M1674: REDESIGNED FUEL PUMP FOR SPORTSTER S AND PAN AMERICA

Purpose for Service Bulletin

To inform dealers that a **new** redesigned Fuel Pump Module is available for the Sportster S and Pan America vehicles.

Figure 1. Old Fuel Pump (61200062)

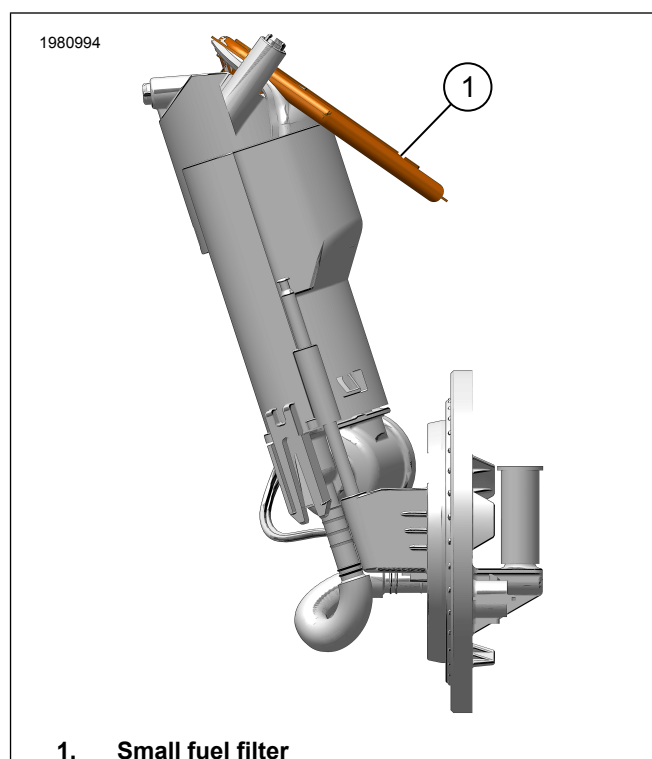
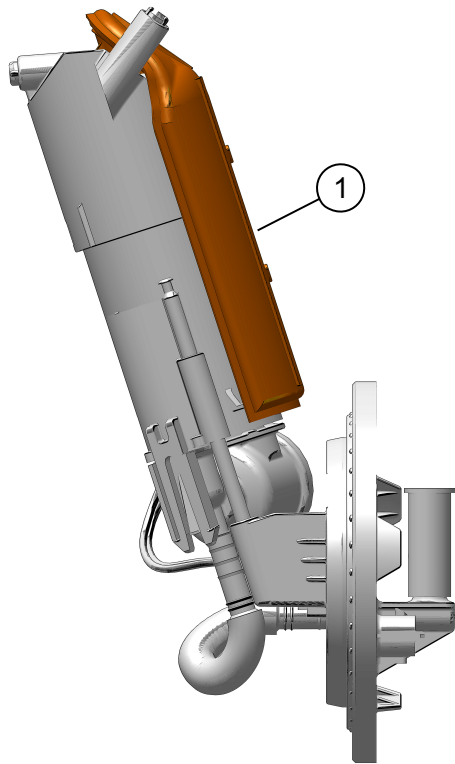
- The **new** Fuel Pump Module (Part No. 61200062A) has a larger fuel filter with new media and a slightly different housing to allow for assembly.
- This **new** Fuel Pump Module is **retrofittable** to all older vehicles.
- The **new** Fuel Filter (Part No. 61200123) is available separately for service but will **only fit the new Fuel Pump Module**.
- **DO NOT** mix old and new parts.
- When making warranty repairs, use the **new** Fuel Pump module (Part No. 61200062A). **Return all old inventory of** (Part No. 61200062) per Table 4.

See Figure 1. Small fuel filter (1) is shown untucked from under plastic cover.

- Start using the **new** fuel pump (Part No. 61200062A).
